**VALUE ENGINEERING SUMMARY
OF
I-75 WIDENING
BETWEEN KY 192 AND KY 80
LAUREL COUNTY, KENTUCKY**

APRIL 13-17, 1998

EXECUTIVE SUMMARY

I.A. Value Engineering Alternate - One Span Bridge

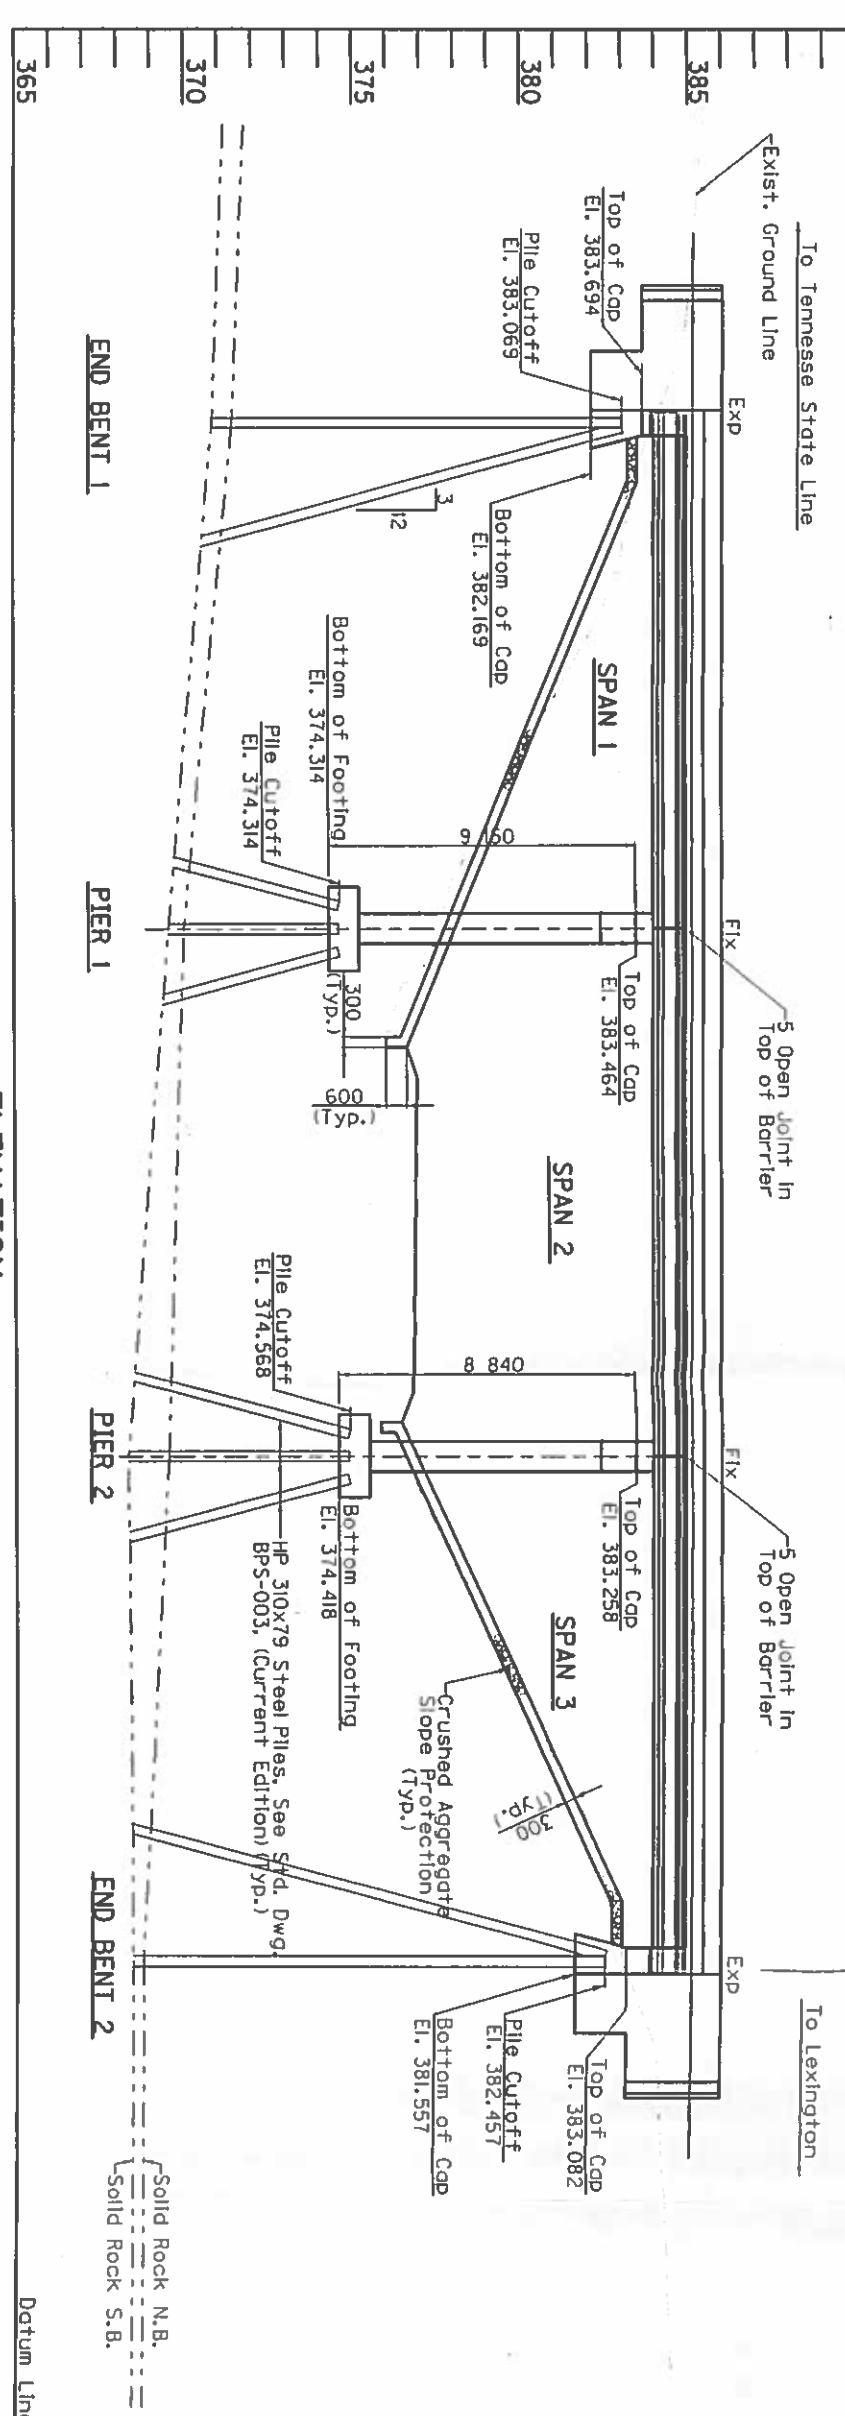
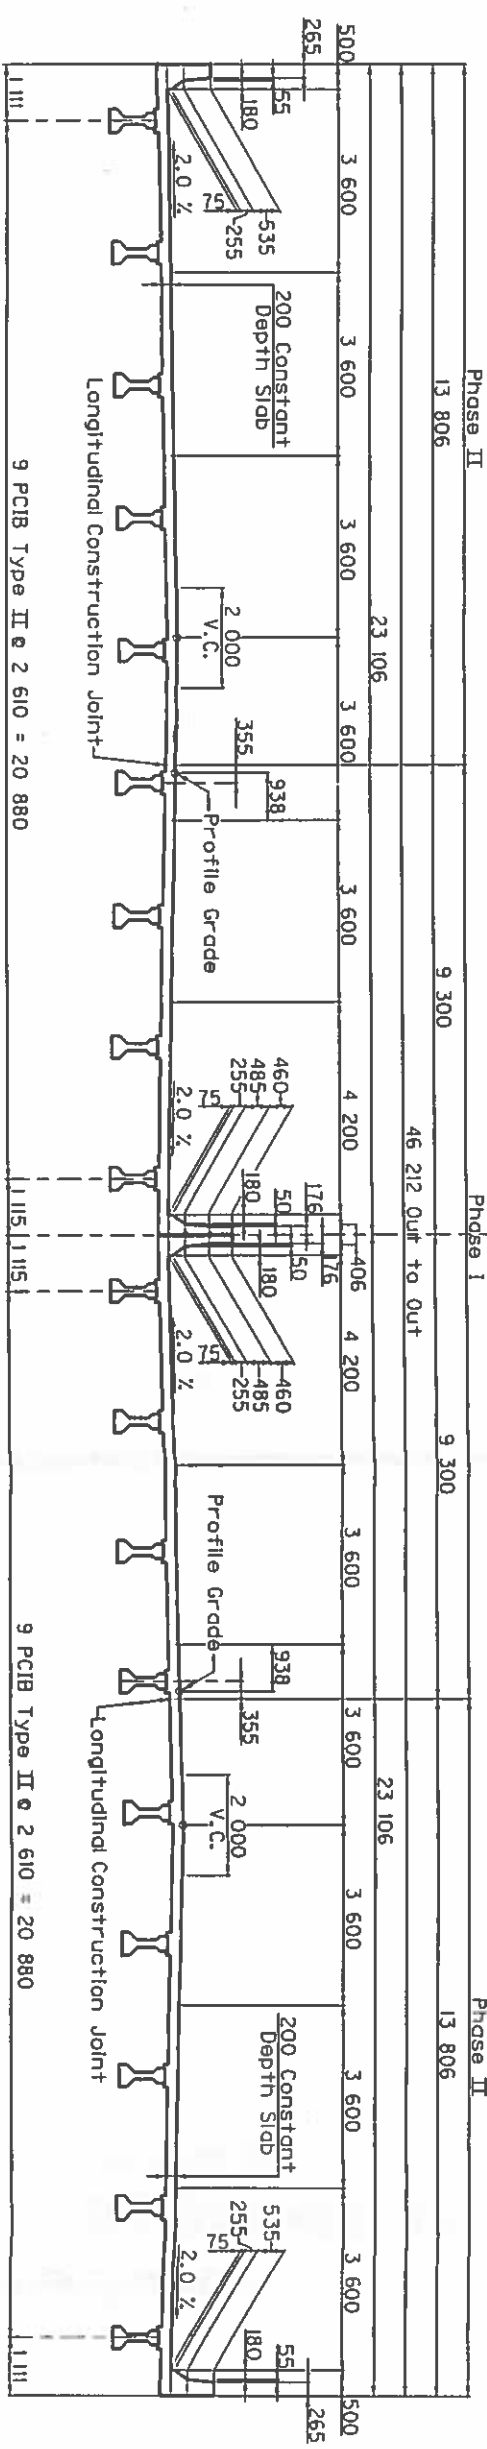
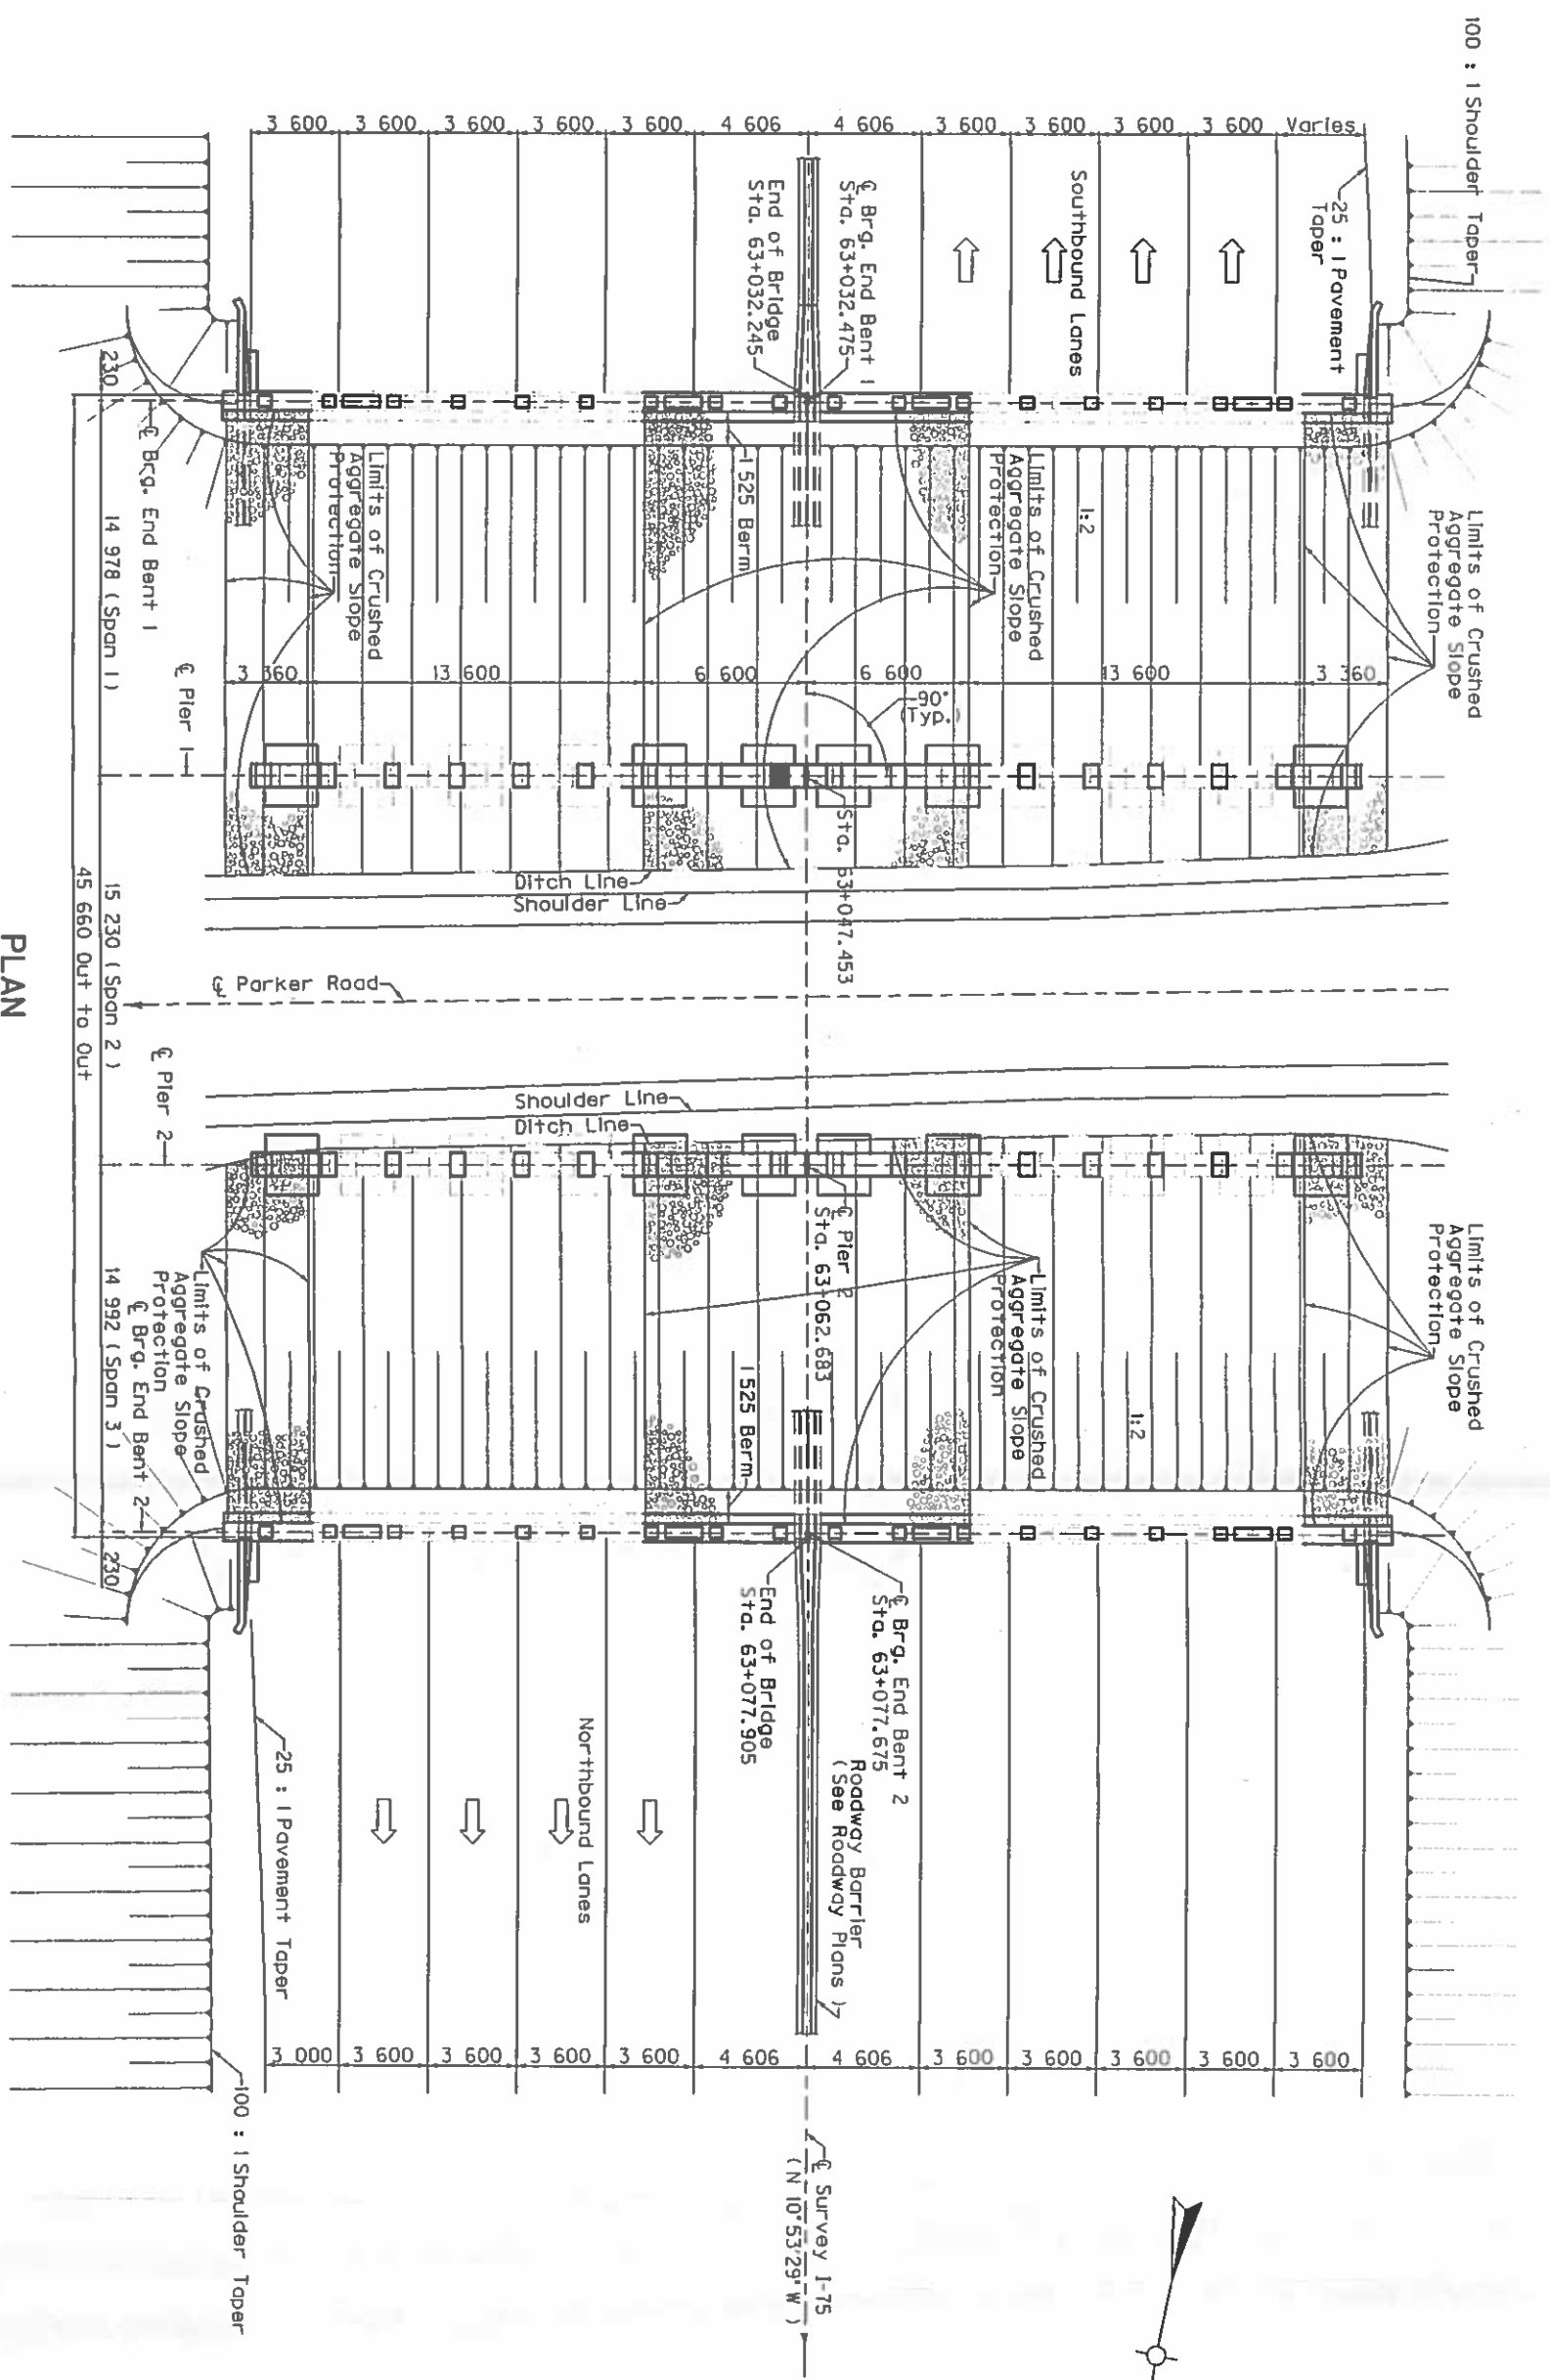
The proposed bridge is a three span (15.02 m-15.24 m-15.02 m) Type II PCIB with pile end bents. The proposed new construction will consist of phase construction. The interior bridge will be constructed in between the existing twin span structures. Once the interior bridge is completed, the superstructure from the existing bridges will be removed and replaced with new Type II PCI beams utilizing the existing substructure units.

The VE alternate is a one span Type III PCIB bridge with Mechanically Stabilized Earth (MSE) walls at the abutments. The length of the spans will decrease from 45.28 meters as above to 22.2 meters. Portions of the old substructure can be left in the ground.

Total = \$ 908,000
Cost Difference from proposed = \$317,000

There will also be need for sheet piling around the retained back of the MSE wall. This sheet piling could remain in place after the project is completed.

TYPICAL SECTIONS AS PROPOSED I-75

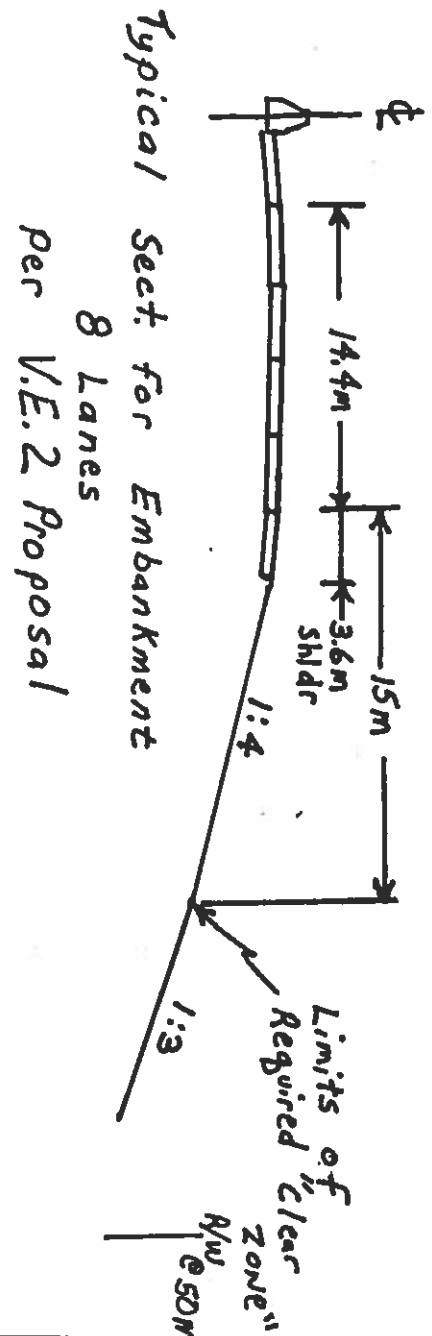
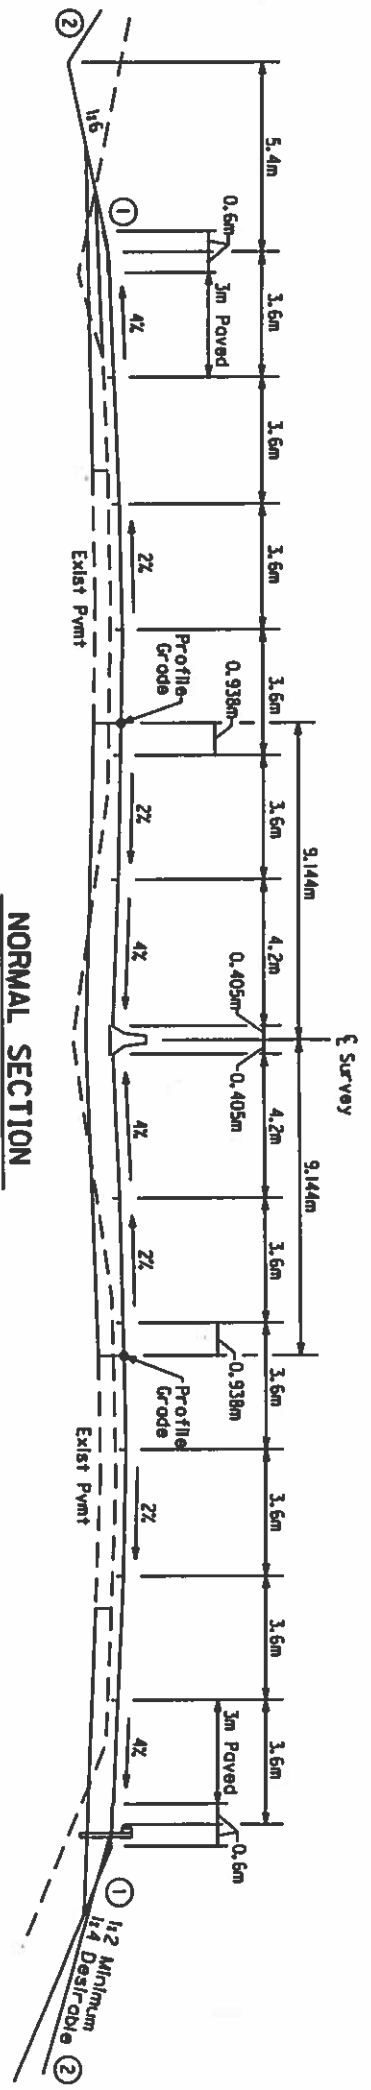
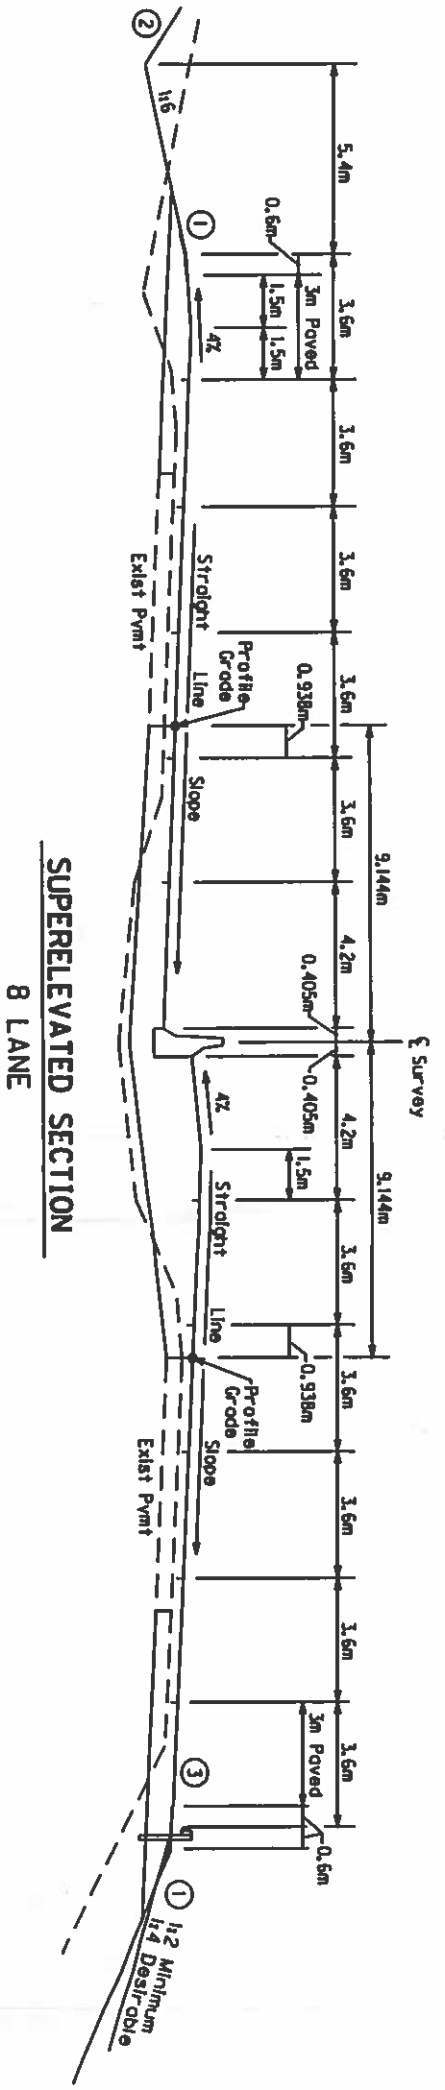
The as proposed for the I-75 mainline at the beginning station is six, 3.6 meter lanes with two, 4.2 meter inside shoulders while the template consists of an eight lane section between the KY 80 and KY 192 interchange.

V. E. 1 Alternative

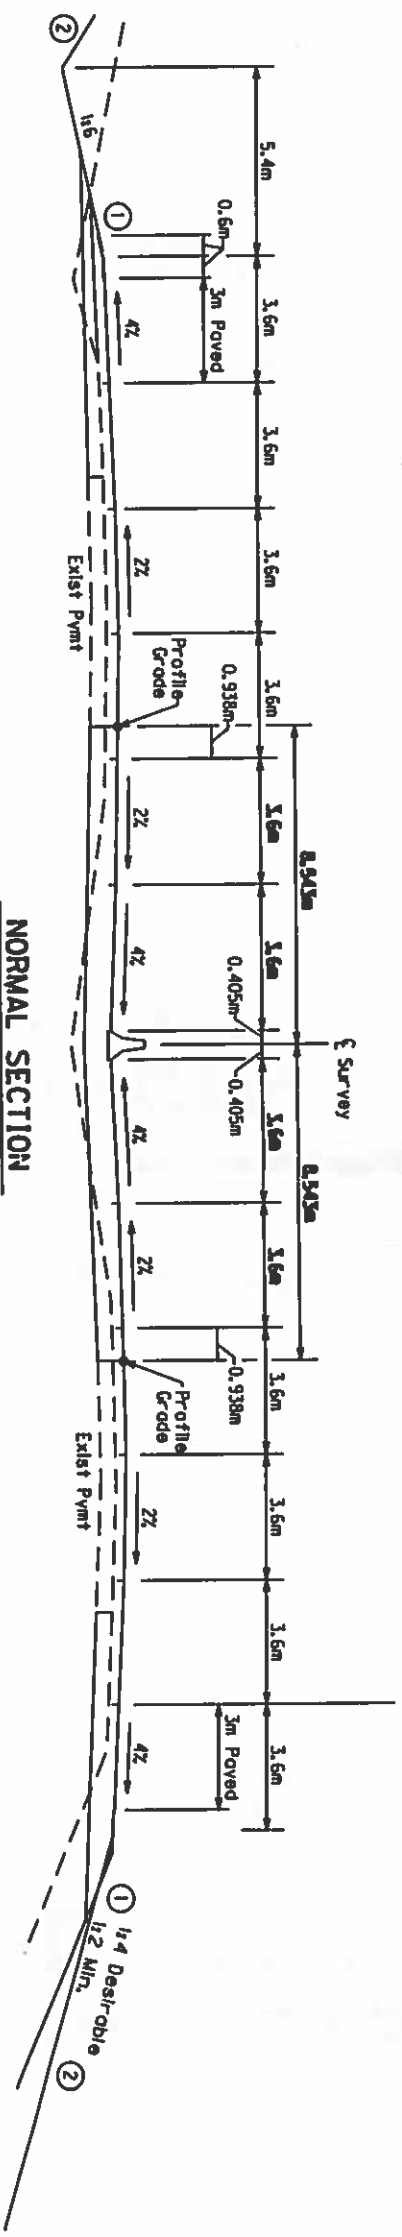
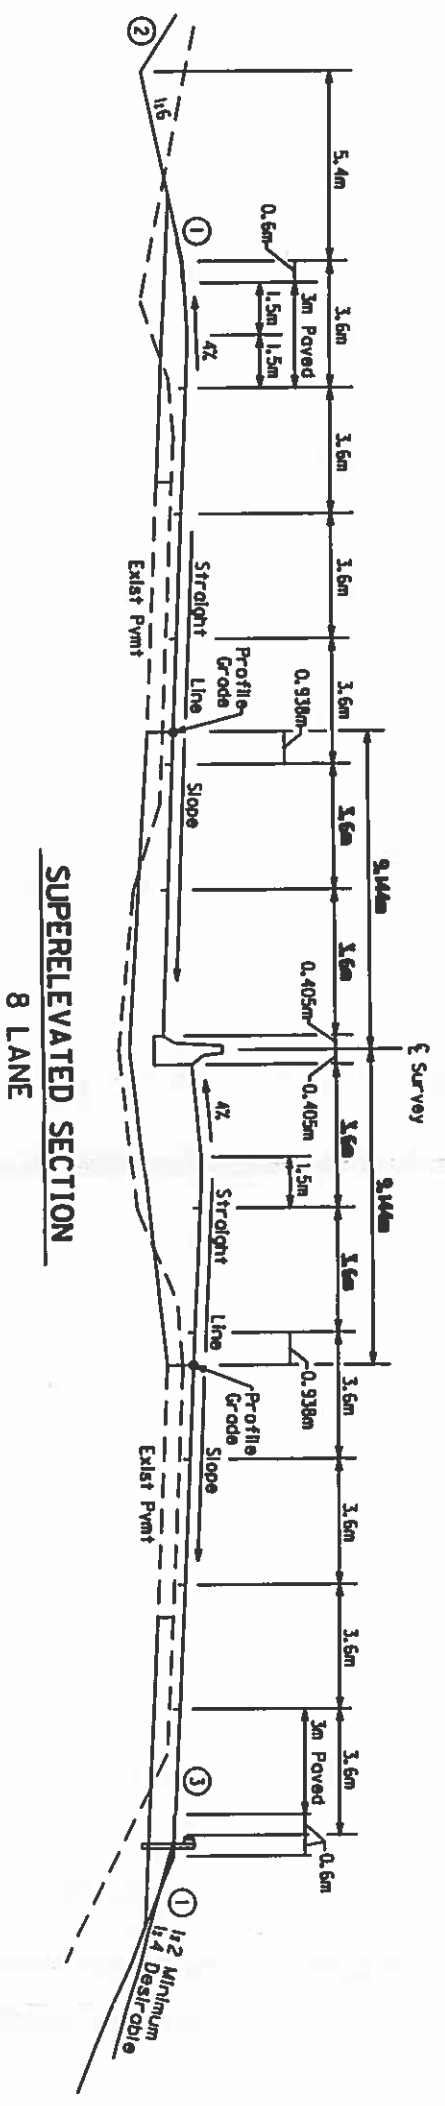
The VE alternate is to reduce the inside shoulder width from 4.2 m to 3.6 m and flatten the embankment slopes to a desirable 4:1.

The Value Engineering Proposal Number 1 recommends reducing the inside shoulder width from 4.2m to 3.6m. No documentation could be found in the "Roadside Design Guide" which supported the need for the additional shoulder width.
